Re: 5 Villiers Road, Padstow Heights – Traffic Response to RFI

I have considered the relevant traffic and parking matters (17 & 18) contained in Council's RFI (DA-26/2025) of 18 March 2025.

Swept Path Assessment & Vertical Clearance Test

SWEPT PATH ASSESSMENT
USE OF BASEMENT FOR FORWARD EXIT
BASEMENT FLOOR

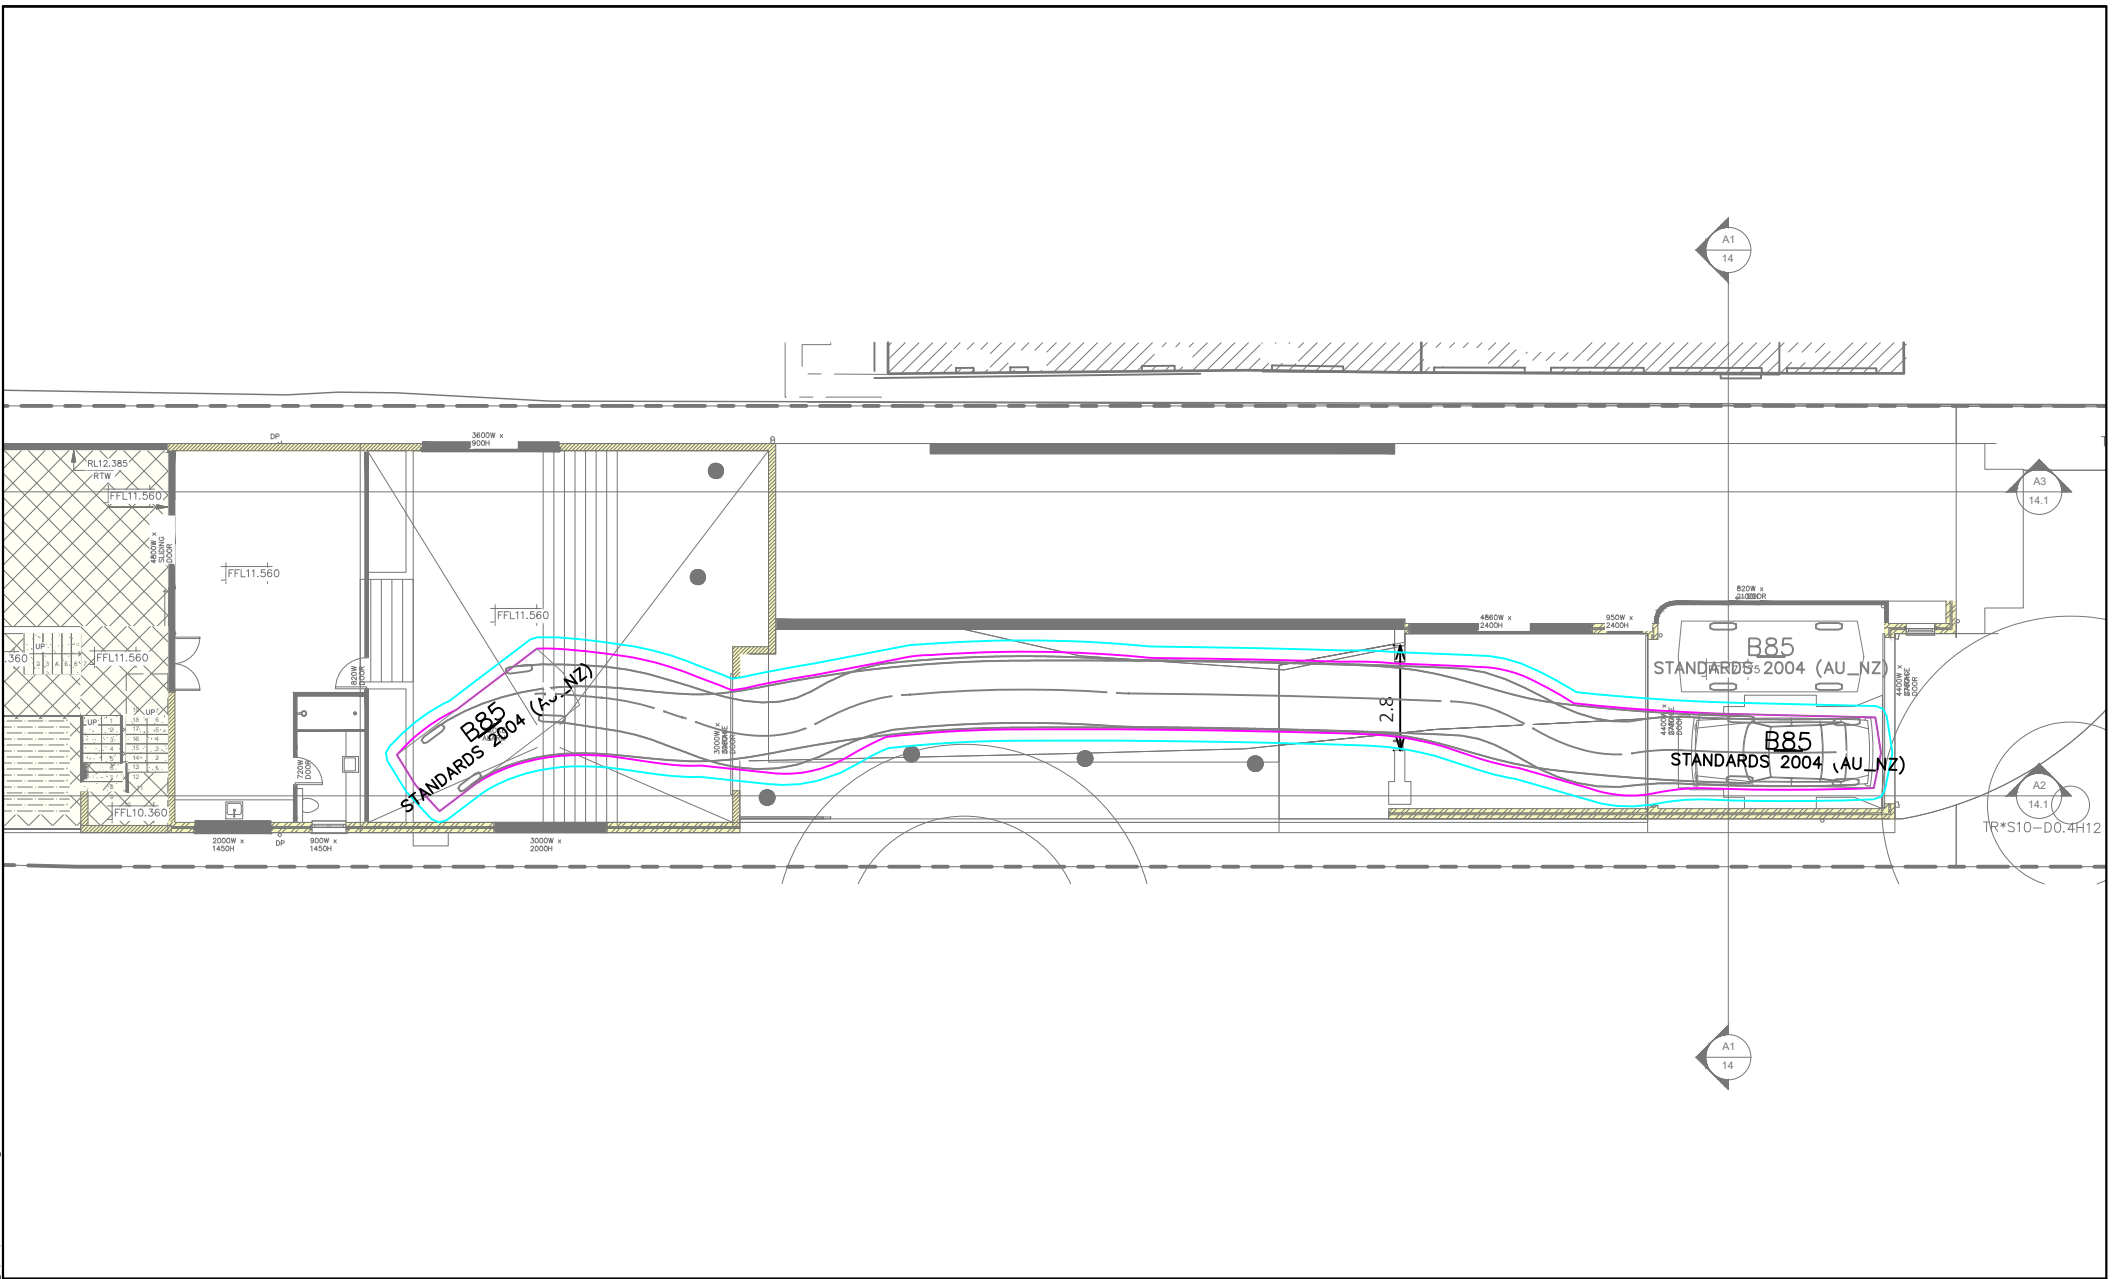
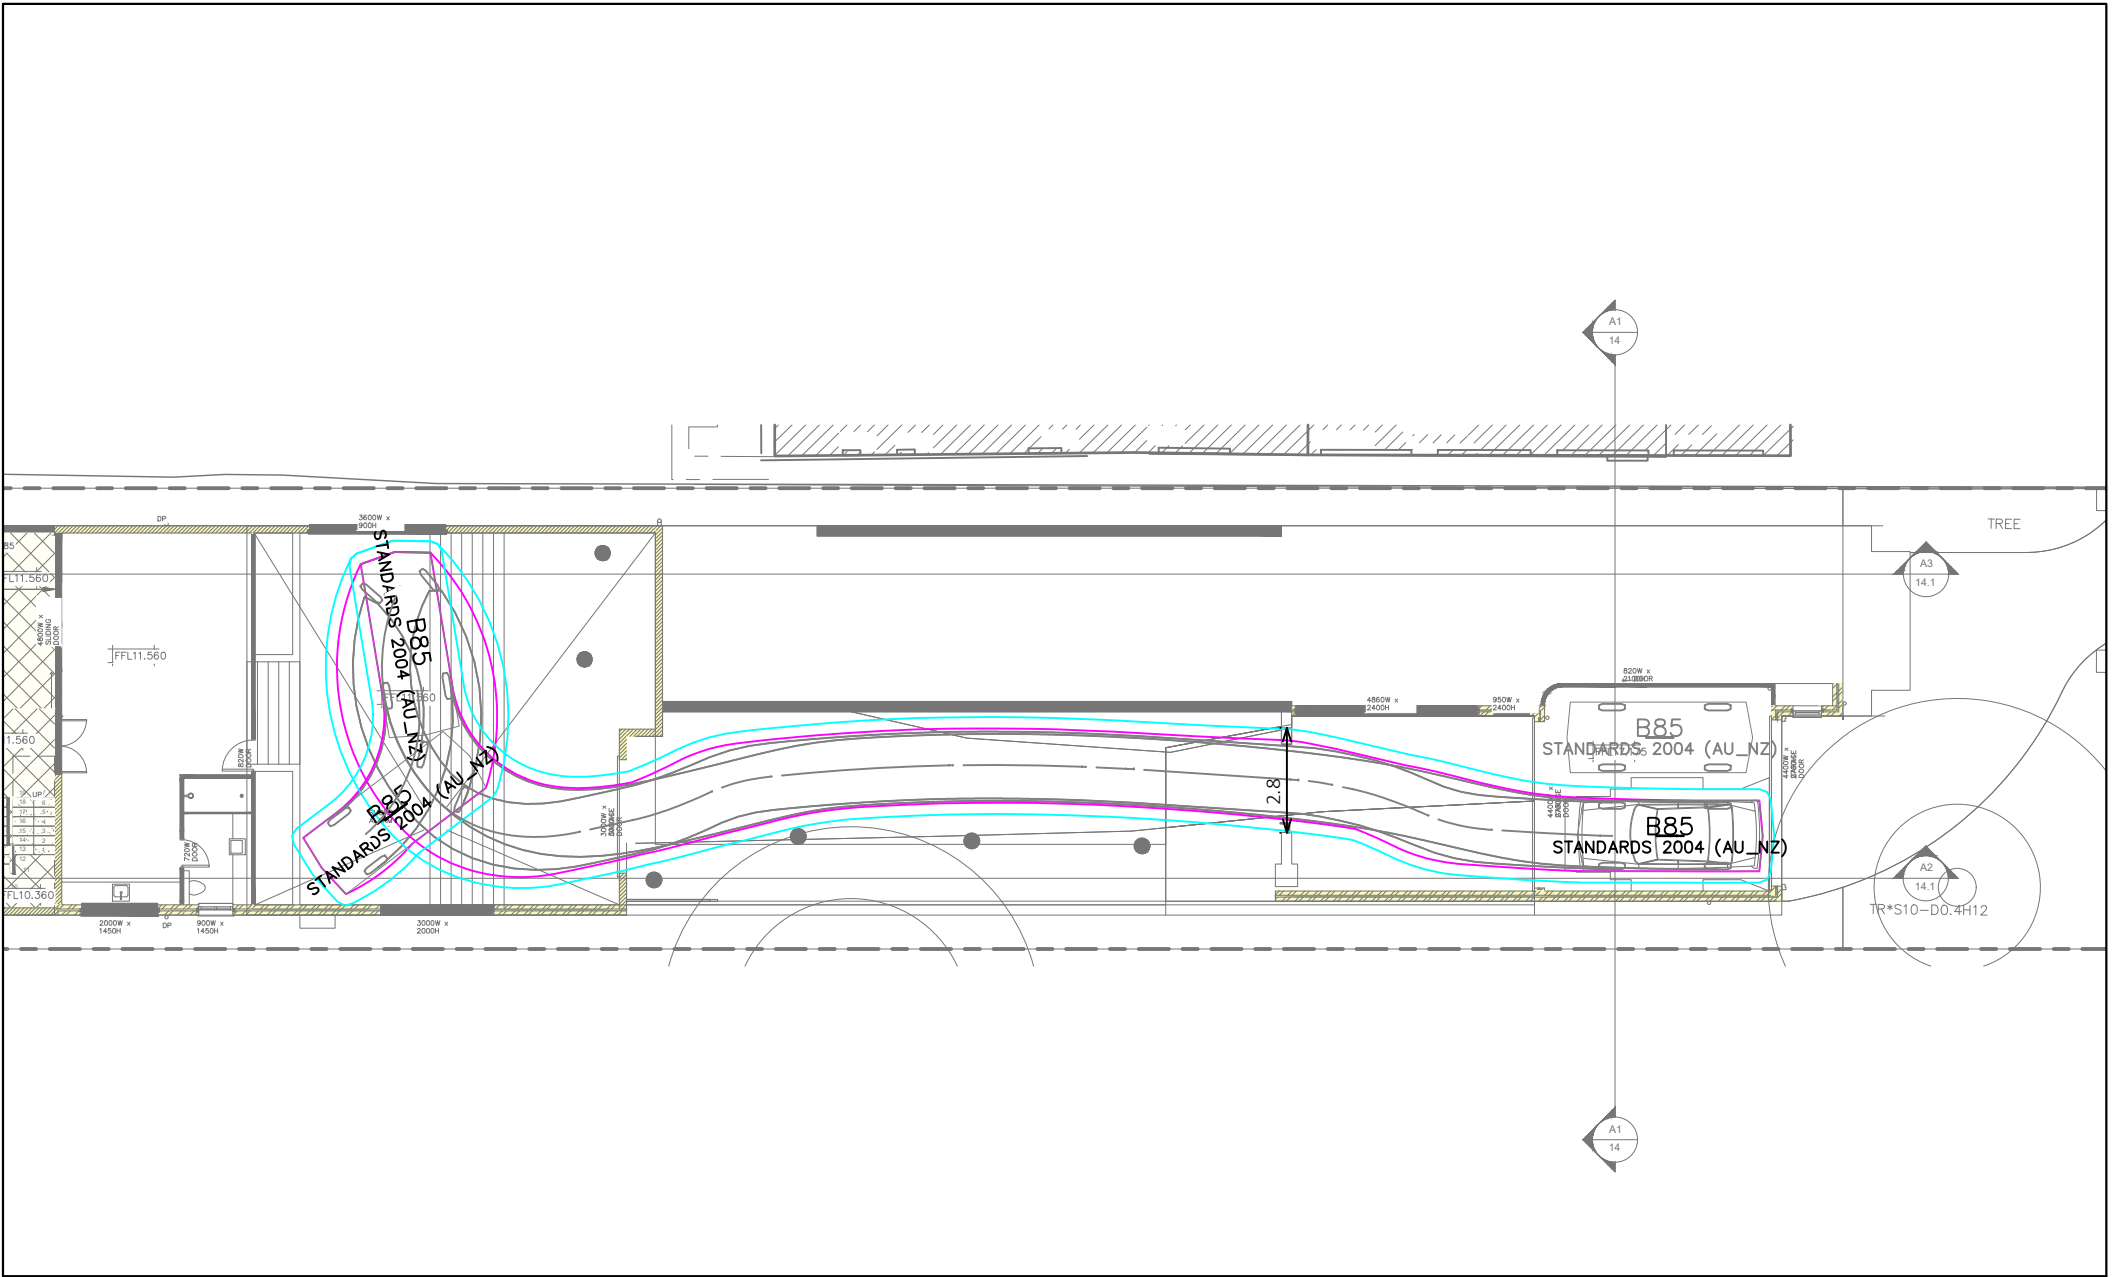
a. The existing VFC & roadway leading to the site does not line up with proposed internal driveway. You shall provide a swept path analysis demonstrating vehicles are capable of manoeuvring from the street to the basement and exit in a forward direction.

The swept path assessment has been undertaken in response to Council's request. The assessment has demonstrated that vehicles can enter and exit the site with no undue difficulty, confirming satisfactory manoeuvring provision (**Attachment 2**).

Sheet Title		
CIVIL SITE PLAN		
Address	5 VILLIERS RD PADSTOW HEIGHTS NSW	Date
Designed	CSY	15/04/25
Drawn	CSY	Checked
DA	CDC	CSY
Drawing No	25CSY179/C01	Scale
		1:100 U.N.O.
		Issue
		A

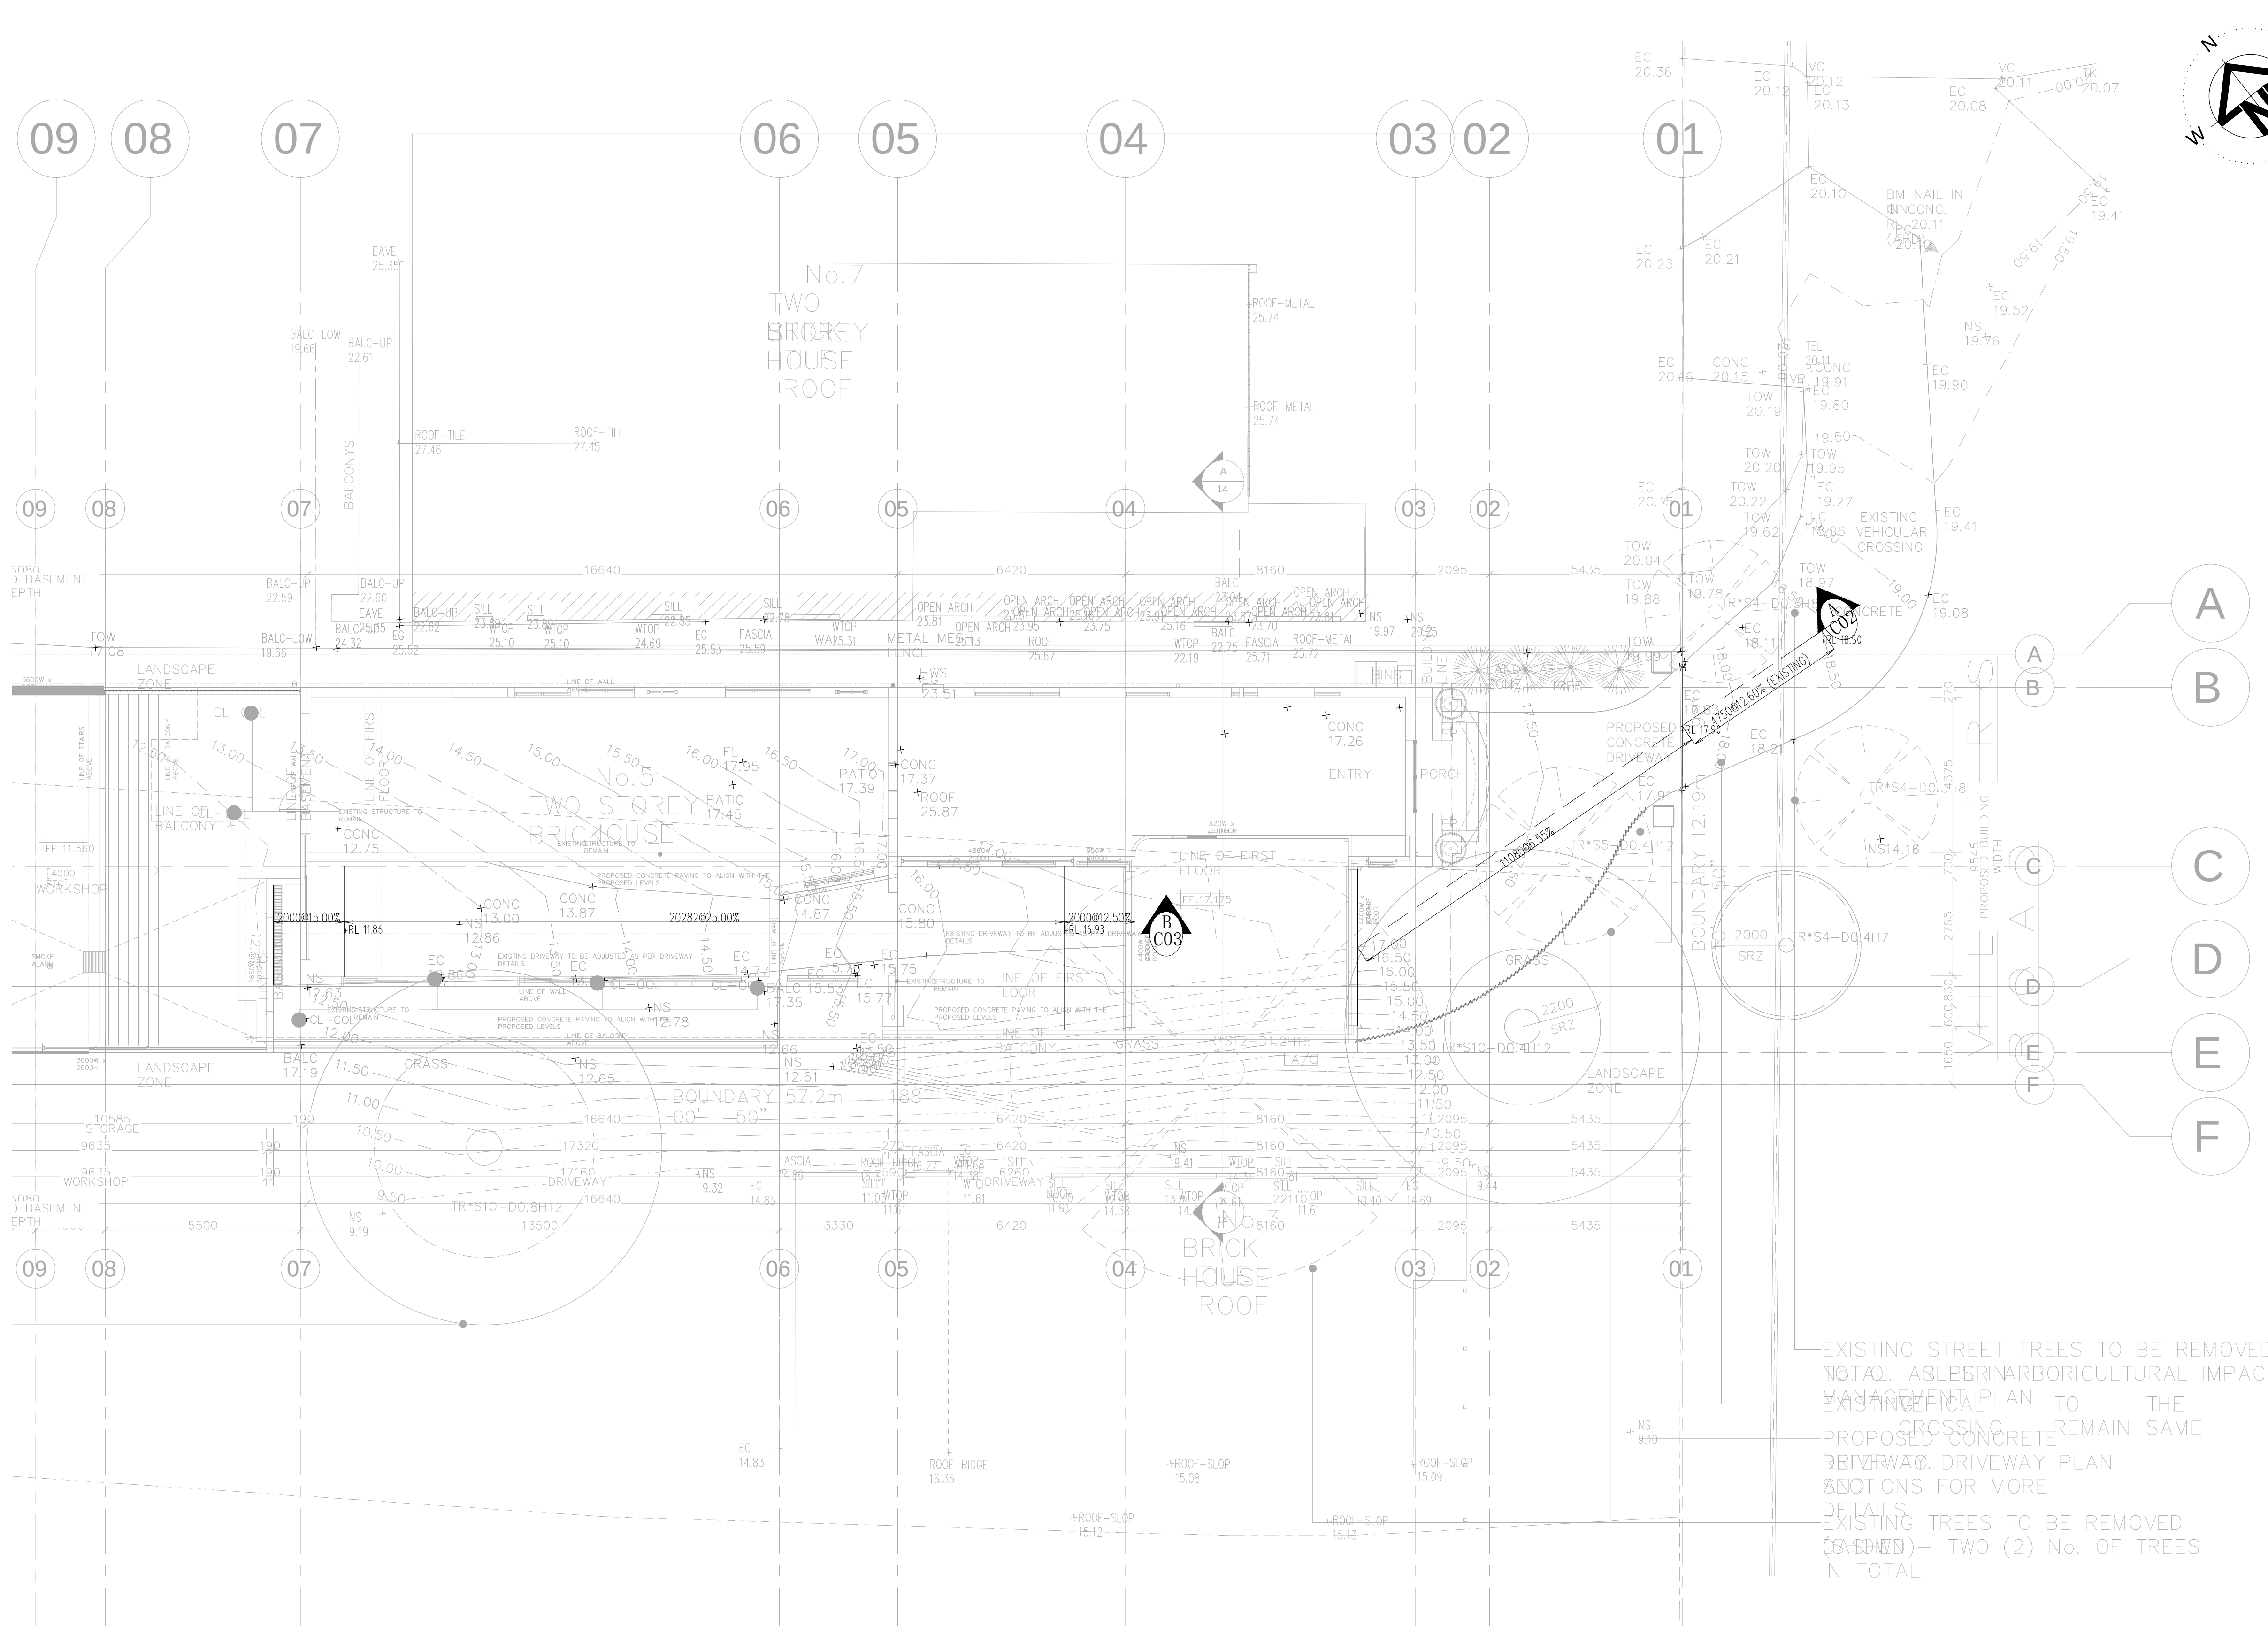
b. As this is a new development, a new VFC shall be designed and provided in accordance with Council's VFC policy and standard drawing S-004.

The architectural plan has also been revised to ensure that the internal driveway aligns with the existing crossover. Details of the civil plans can be found in **Attachment 3**.
